1111 19th Street NW > Suite 402 > Washington, DC 20036  
t 202.872.5955 f 202.872.9354 www.aham.org

May 18, 2020

Re: ENERGY STAR Program Requirements, Product Specification  
for Residential Dishwashers, Eligibility Criteria, Draft 1, Version 7.0

The Association of Home Appliance Manufacturers (AHAM), respectfully submits the following comments regarding the ENERGY STAR Product Specification for Residential Dishwashers, Eligibility Criteria, Draft 1, Version 7.0.

**Figure 4—255 kWh/year Results**

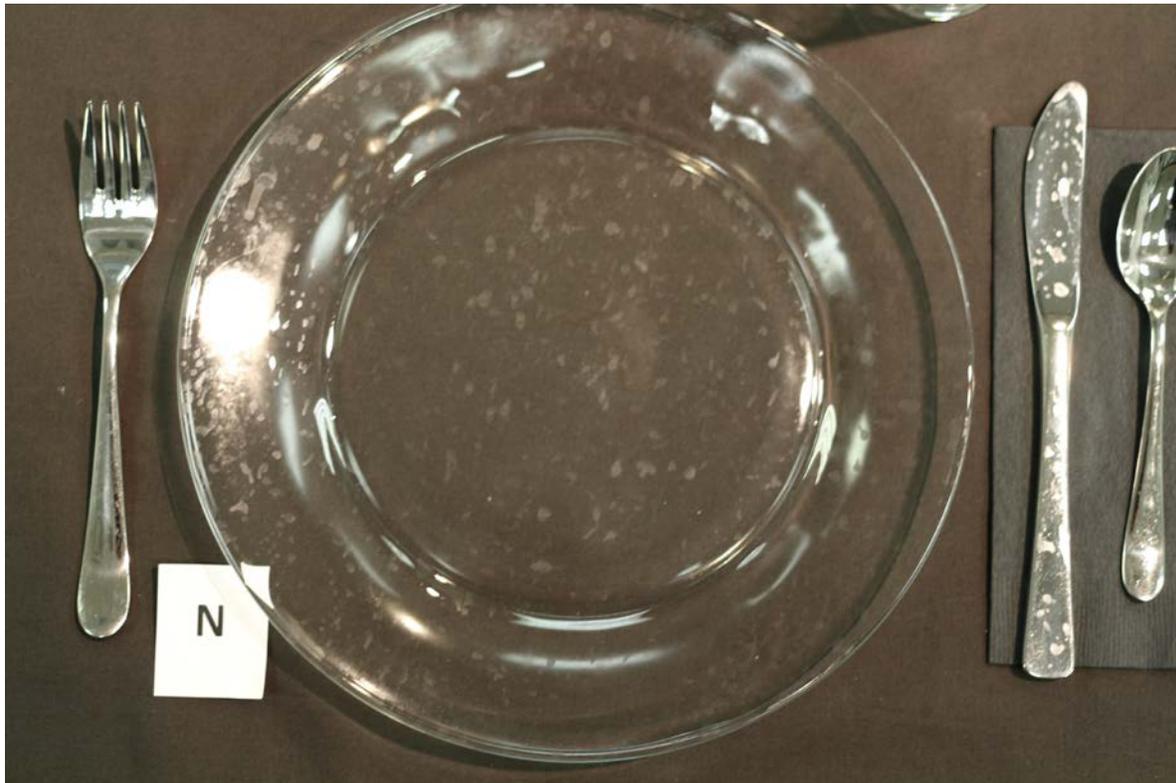
AHAM displayed one place setting from each dishwasher after that place setting had run through the normal cycle three times. Photographs of those place settings are displayed below in Figures 3-5. DOE and Navigant were asked to consider whether, as consumers, they would eat off of the dishes or would serve friends/family from the dishes. As the pictures show (and is more evident when viewed in-person), there is some residue on the place setting cleaned in the 307 kWh/year dishwasher. But the 255 kWh/year and 234 kWh/year dishes contain significantly more greasy residue.
